Bulletin | Danfoss Turbocor Compressors

Customer Notification

B-CN-180-EN

SUBJECT: Service Monitoring Tools (SMT) 3.4.1 Released

Stepper Control Changes

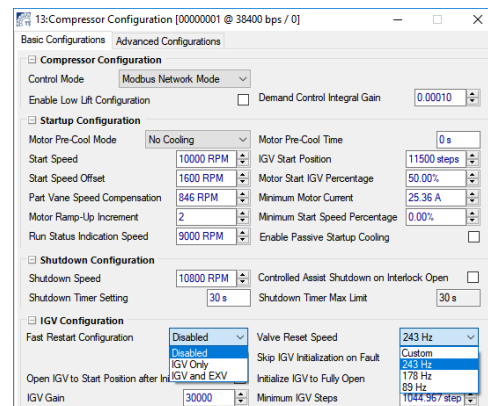
Firmware version 4.2.0 introduced the ability to include a Fast Restart on the EXVs, as well as the ability to adjust the Valve Reset Speed for the EXVs.

Startup Cooling

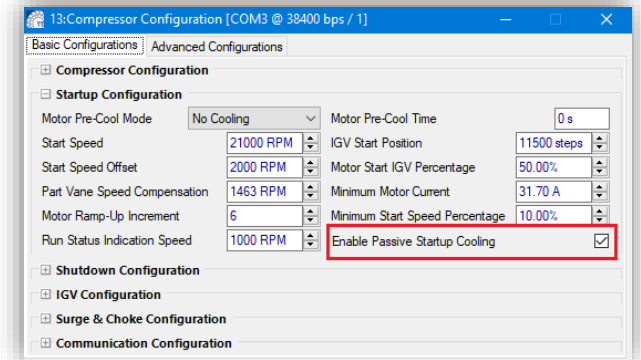
Firmware version 4.2.0 introduced the ability to disable Passive Cooling mode during startup and enable Dynamic Cooling.
